Project/File: **Live-Work Units/ GC22-0014/ DSRFY2022-0016**
 This is a design review application to allow for the construction of 16 live-work units on 0.7-acres.

Lead Agency: Garden City

Site address: 209, 211, 213 & 215 E. 34th Street

SITE PLAN

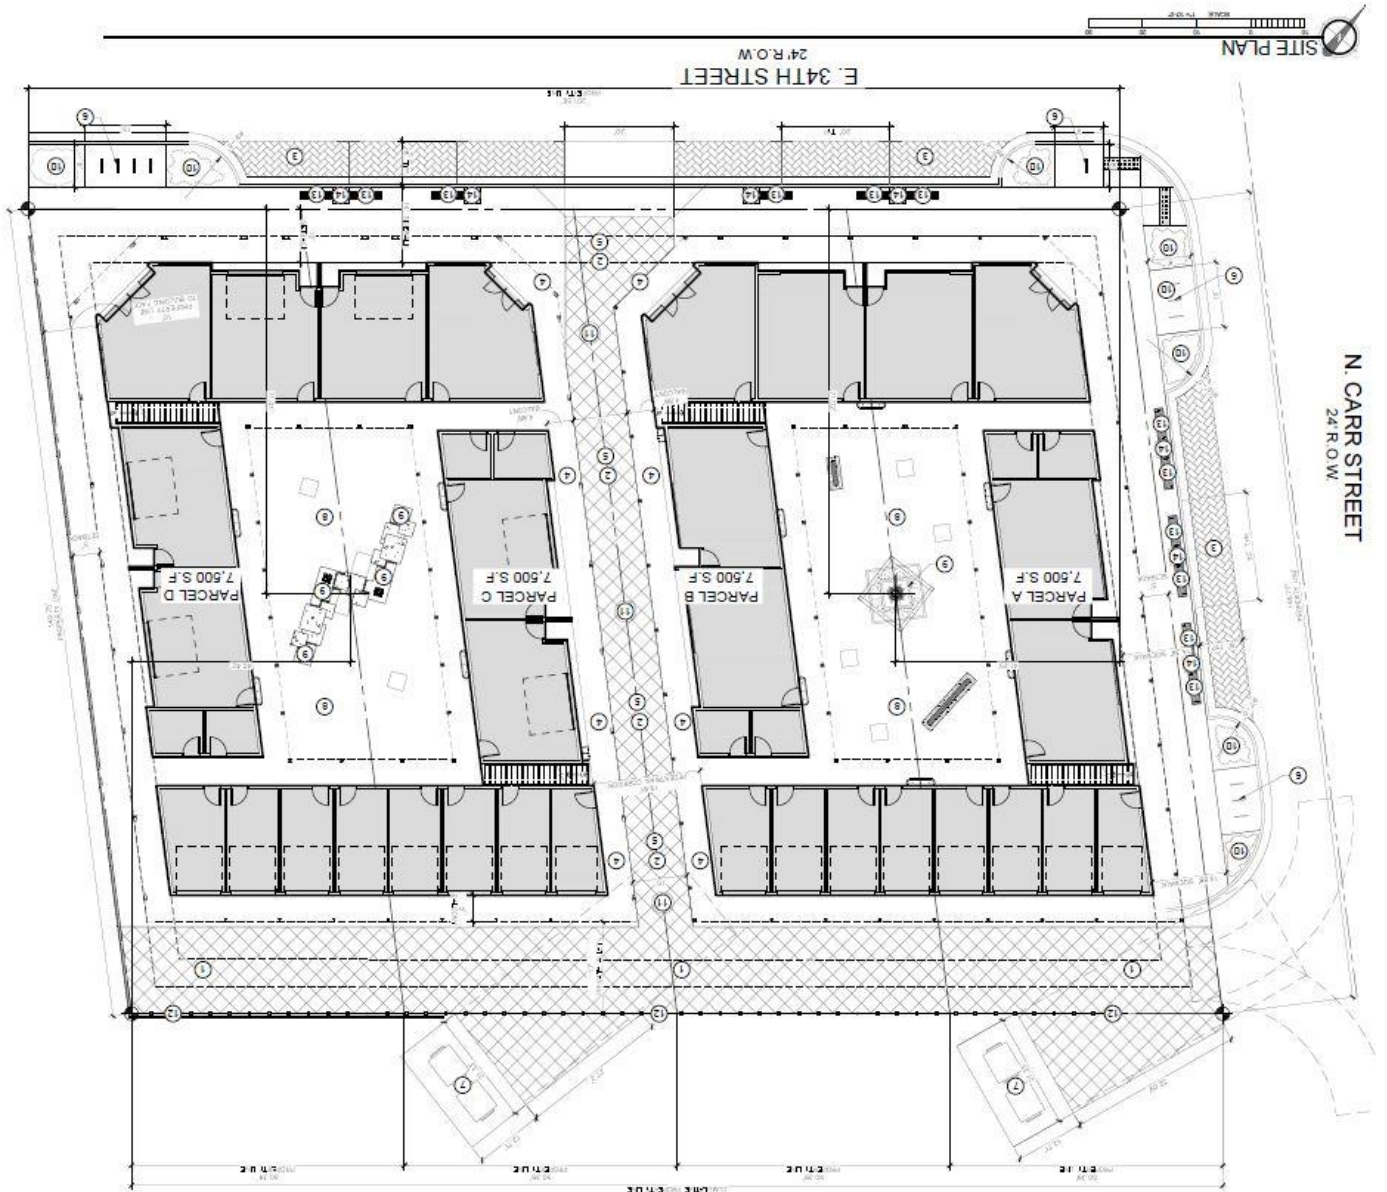
- d. **Staff Comments/Recommendations:** The applicant's proposal to construct 34th Street as ½ of a 36-foot wide commercial street section with vertical curb, gutter and 14-foot wide concrete sidewalk abutting the site exceeds District policy which requires the construction of 5-foot wide concrete sidewalk and should be approved as proposed.

The applicant should be required to dedicate additional right-of-way on 34th Street to 2-feet behind back of sidewalk abutting the site.

The applicant's proposal to install permeable pavers within the on-street parking area of 34th Street abutting the site should not be approved as proposed, as there is a bulb-out proposed with street trees located within the bulb-out at the intersection of 34th Street and Carr Street and would create a maintenance burden for ACHD. If the street trees are located behind the back of sidewalk, then the applicant should be required to install permeable pavers within the on-street parking area of 34th Street abutting the site.

The applicant's proposal to construct a bulb-out at the intersection of 34th Street and Carr Street should be approved, as proposed. The applicant should be required to provide a minimum of 24-feet of pavement between the bulb-outs at the intersection (measured face-of-curb to face-of-curb). Street trees are not allowed within the bulb-out if permeable pavers are installed within the parking area of 34th Street.

The applicant's proposal to construct a bulb-out located at the site's northwestern property line on 34th Street should not be approved as proposed, as it creates two bulb-outs within a short distance of each other.

- d. **Staff Comments/Recommendations:** The applicant's proposal to construct Carr Street as ½ of a 36-foot wide commercial street section with vertical curb, gutter and 14-foot wide attached concrete sidewalk abutting the site exceeds District policy which requires the construction of 5-foot wide concrete sidewalk and should be approved as proposed.

The applicant should be required to dedicate additional right-of-way on Carr Street to 2-feet behind back of sidewalk abutting the site.

The applicant's proposal to install permeable pavers within the on-street parking area of Carr Street abutting the site, should not be approved as proposed, as there is a bulb-out proposed with street trees located within the bulb-out at the intersection of Carr Street and 34th Street and would create a maintenance burden for ACHD. If the street trees are located behind the back of sidewalk, then the applicant should be required to install permeable pavers within the on-street parking area of Carr Street abutting the site.

The applicant's proposal to construct a bulb-out at the Carr Street/34th Street intersection should be approved, as proposed. The applicant should be required to provide a minimum of 24-feet of pavement between the bulb-outs at the intersection (measured face-of-curb to face-of-curb). Street trees are not allowed within the bulb-out if permeable pavers are installed within the parking areas of the roadways.

The applicant's proposal to construct a bulb-out located at the site's southeastern property line on Carr Street should not be approved as proposed, as it creates two bulb-outs within a short distance of each other.

d. **Staff Comments/Recommendations:** The applicant's proposal to close the two existing driveways onto 34th Street meets District policy and should be approved, as proposed.

The applicant's proposal to construct a 20-foot wide paved shared driveway onto 34th Street located 338-feet northeast of Clay Street meets District policy and should be approved, as proposed.

1. Construct 34th Street as ½ of a 36-foot wide commercial street section with vertical curb, gutter and 14-foot wide concrete sidewalk abutting the site, as proposed. Dedicate right-of-way to 2-feet behind back of sidewalk abutting the site.

2. Construct a bulb-out at the intersection of 34th Street and Carr Street as proposed. Provide a minimum of 24-feet of pavement between the bulb-outs at the intersection. Street trees are not allowed within the bulb-out if permeable pavers are installed in the parking areas of Carr Street or 34th Street.

3. Construct Carr Street as ½ of a 36-foot wide commercial street section with vertical curb, gutter and 14-foot wide attached concrete sidewalk abutting the site, as proposed. Dedicate right-of-way to 2-feet behind back of sidewalk.

4. Install permeable pavers within the parking areas of 34th Street and Carr Street abutting the site, if all street trees are located behind the back of sidewalk.

5. Close the two existing driveways onto 34th Street with vertical curb, gutter and sidewalk, as proposed.
6. Construct a 20-foot wide paved shared driveway onto 34th Street located 338-feet northeast of Clay Street, as proposed.
